# **PLANNING & ZONING AGENDA ITEM #5**

***SUBJECT:*** Approval of a Preliminary Plat for Westown Meadows Plat 2

RE: Westtown Meadows Plat 2 – Preliminary Plat

**PRELIMINARY PLAT  
WESTTOWN  
MEADOWS  
PLAT 2**

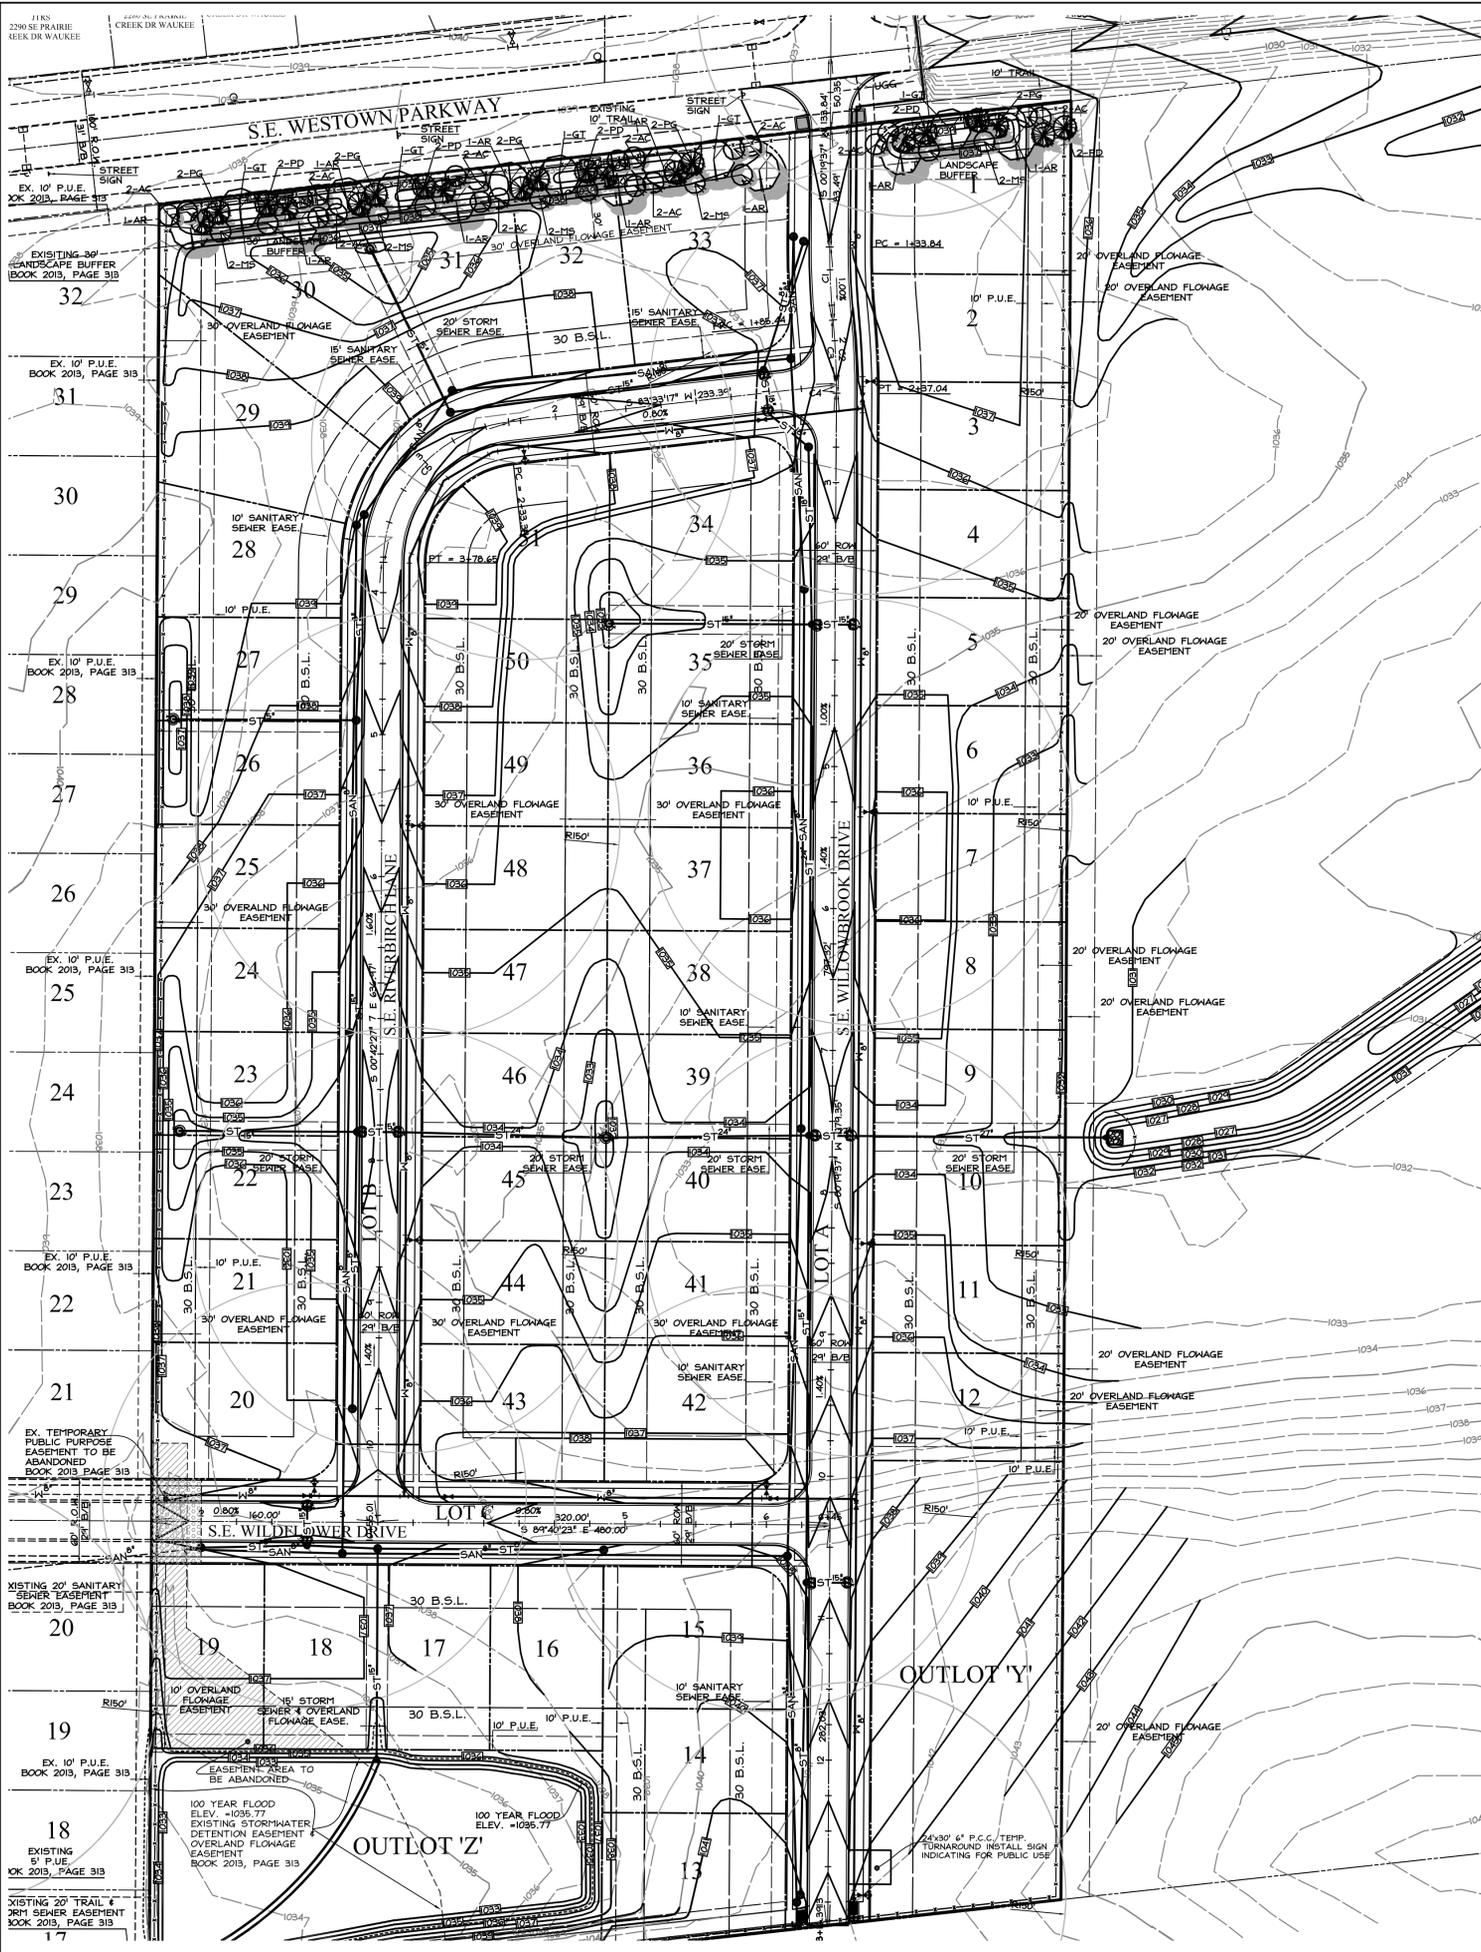
1. A note should be added to the plat indicating Outlot Z to be maintained by the homeowner's association. Additionally, Note #1 should be revised to include the future maintenance responsibility of all landscape buffers by the Homeowner's Association after the initial plantings are installed by the developer.

2. The proposed park ground should be indicated in an outlot and a note provided on the plat indicating the dedication of Lots A, B, C, and Outlot X (Parkland) to be dedicated to the City of Waukeee.

3. The existing 10 foot trail along the south side of SE Westtown Meadows should be indicated on the plat for clarity. Additionally, the planned portion of 10 foot trail east of the Westtown/Willowbrook intersection adjacent to Lot 1 would need to be installed as a part of this plat.

4. **The proposed public improvements that were approved for Grant Park Plat 3 should be indicated on the plat in halftone for reference. A copy of those plans has been attached for your use.**

5. Staff would request that the proposed SE Prairie Creek Drive be revised to a new name as it is not in good progression with the existing portion of that street to the north. Staff would suggest SE Riverbirch Lane as a possible name. Please address.

6. **All existing easements through the plat or adjacent to the plat which were recorded as a part of Westtown Meadows Plat 1 should be indicated on the plat with Book and Page.**

7. Any portion of the existing detention and overland flowage easement through the proposed Outlot Z and Lots 16—19 needing to be abandoned should be indicated on the plat for clarity. **The 100-year flood limits should be illustrated on the preliminary plat for clarity. Staff still believes that the proposed grades in and surrounding Outlot Z will extend a 100-year storm event into the rear yards of lots 13—29 which should be addressed by additional change in proposed grades and or easements across the lots reflective of the storm water area during this type of storm event. Staff would prefer to see the entire 100 year flood entirely accommodated within Outlot Z if at all possible. Please address.**

8. All proposed easements should be indicated on the plat including: storm sewer, overland flowage, sanitary sewer, detention, off-site temporary detention, temporary overland flowage, etc. **The proposed 15 foot storm sewer easements between lots should be revised and indicated as 20 foot lots.**

9. An overland flowage easement should be provided in the rear yards of Lots 30—33 for the flow of water to the intake in the rear of Lot 31.

11. The public utility easement proposed to run through the eastern portion of the proposed Parkland should be revised to run along the southern 10 feet of Lot 12 back toward SE Willowbrook Drive to the west so that there are no easements running through the Park. Additionally, the front and rear yard setbacks can be removed from the park ground.

12. The width of street proposed for SE Willowbrook Drive may be reduced to a 29 foot b/b street and the width of SE Prairie Creek Drive increased from 26 foot b/b to 29 foot b/b.

13. Verify the alignment of the proposed approach of SE Willowbrook Drive matches the centerline of the existing portion of street to the north. It appears that the ROW matches the existing portion to the north, but the actual pavement centerline does not align from north to south.

14. **Verify the grades along SE Westown Parkway based upon the approved plans for Grant Park Plat 3.**
15. ~~Verify all overland flowage easements, permanent and temporary, are at 2% grade across each lot. This should include the proposed drainage swale from this plat over to the temporary detention basin proposed on a portion of the planned multi-family property.~~

16. The temporary detention pond and temporary overland flowage easements needed to accommodate the proposed outletting of water to the east should be identified on the preliminary plat. Staff would request that the temporary detention pond be situated in close proximity to the location(s) identified on the concept plan submitted with the rezoning and not adjacent to the proposed Lots 1 – 12 to avoid any potential issues in the future between the single family home properties and an apartment development. **Staff also requests permanent overland flowage easements be provided on the east side of Lots 1 – 12 on the planned multi-family property to collect and distribute the stormwater from those properties toward the storm sewer outlet point and then directing the water over to the temporary detention pond so that the overland flowage easement can be established at 2% grade and keep the water away from the single family lots. Please address.**

17. Street grades should be indicated on the preliminary plat.
18. Berming for the landscape buffer through the northern portion of Lot 1 should be indicated on the plat.

19. Storm water computations should be provided for review as a part of the next submittal.
20. **Hydrant radii should be indicated on the preliminary plat for clarity on spacing proposed.**

21. Staff questions if the applicant will be able to secure the necessary temporary turnaround easement or if a solution working with the Parkland should be explored. Staff will discuss further and provide a possible scenario to the applicant for consideration. Please address.

22. **Verify the legal description of the plat is accurate as there is reference to “Government Lot 14 and 14 which should be resolved.**
23. ~~Staff would request that the future circulation plan be eliminated from the preliminary plat. Please address.~~
